Table 1: List of Issues, Commenters and Comment Evaluation Process Summary

- I. Introduction 1
- II. Public Comment Process Overview 1
- III. Evaluation of Issues by Standard 2
 - III.A. General Standard of Review (OAR 345-022-0000) 2

On December 16, 2025, the Oregon Department of Energy (Department or ODOE) issued its Proposed Order on RFA4. On the same date, in accordance with OAR 345-027-0367(4), the Department issued a Public Notice, initiating a 45-day comment period, to conclude on January 30, 2026. The Notice also established deadlines for the subsequent comment evaluation process, including:

Figure 1. Original and Revised Collector Substation Location and Transmission Corridor

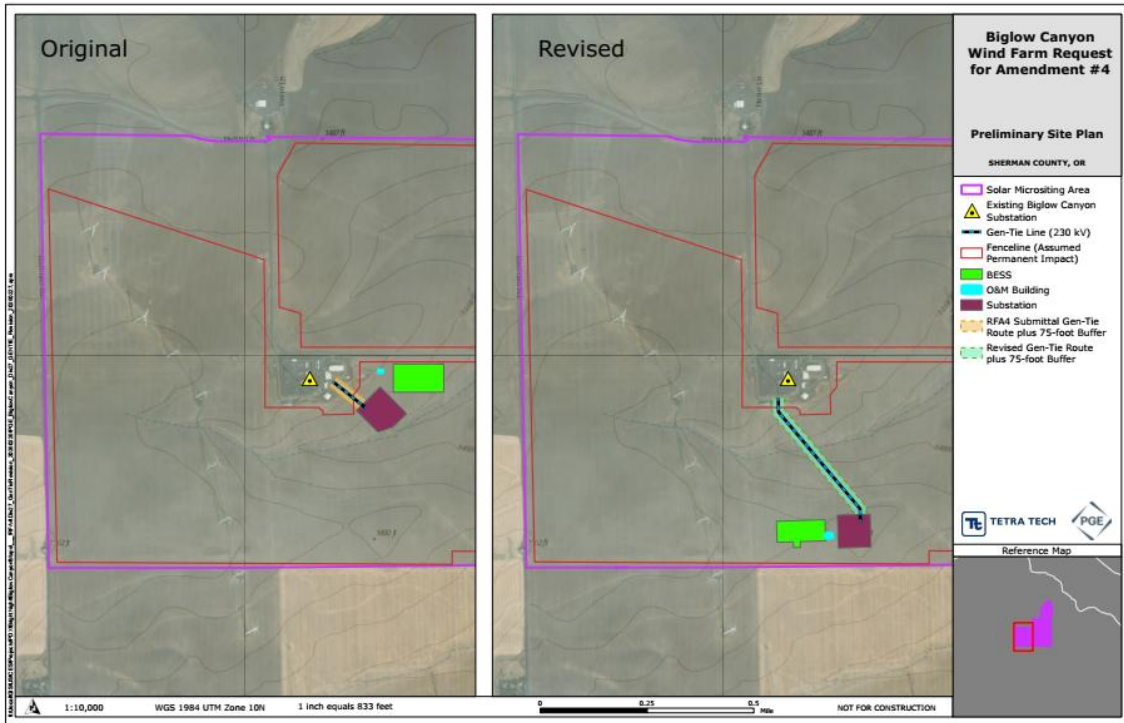
Under OAR 345-025-0010(5), the Council must specify an approved corridor for any transmission line approved in a site certificate. The Department disagrees with the certificate holder's proposed changes. The certificate holder only included one proposed corridor for the 600-foot segment of 230 kV transmission line in the Request for Amendment, which was presented in RFA4 Figure 2.2.

In its response to this issue the Department notes that if the certificate holder wishes to change the alignment of the transmission line it must present the alternate corridors so that they can be evaluated for compliance with applicable laws, rules and standards.

In its reply, the certificate holder explained that continued engineering evaluation of site conditions and infrastructure layout identified that the original substation site presented constraints relative to the existing infrastructure. Accordingly, a new location for the proposed substation and battery energy storage system (BESS) was identified to avoid low elevation areas, better align with existing infrastructure, and improve constructability, long-term operability, and overall infrastructure resilience. The certificate holder asserts that this refinement reflects prudent final engineering and results in improved consistency, new and existing infrastructure, rather than a change in project scope. Moving the collector substation location results in a corresponding adjustment to the transmission line corridor, with an updated alignment of a 230-kV transmission line approximately 1,900 feet in length, supported by three 80-foot tall steel monopole structures. The figure below shows the new location of the project substation and gen-tie transmission line, all still located within the Solar Micrositing Area.

The newly proposed substation location is within the proposed Solar Micrositing Area and has been fully surveyed and evaluated for all applicable resources and impacts. In addition, there do not appear to be any residences or linear structures that could be inadvertently energized within the refined corridor. Accordingly, the Department recommends the Proposed Order and draft Amended Site Certificate be amended with the revised substation location. Site certificate conditions will require an updated site plan, acoustic modeling, retirement estimate, and other resource studies to be provided prior to construction. III.J. Noise Control Regulation (OAR 340-035-0035)
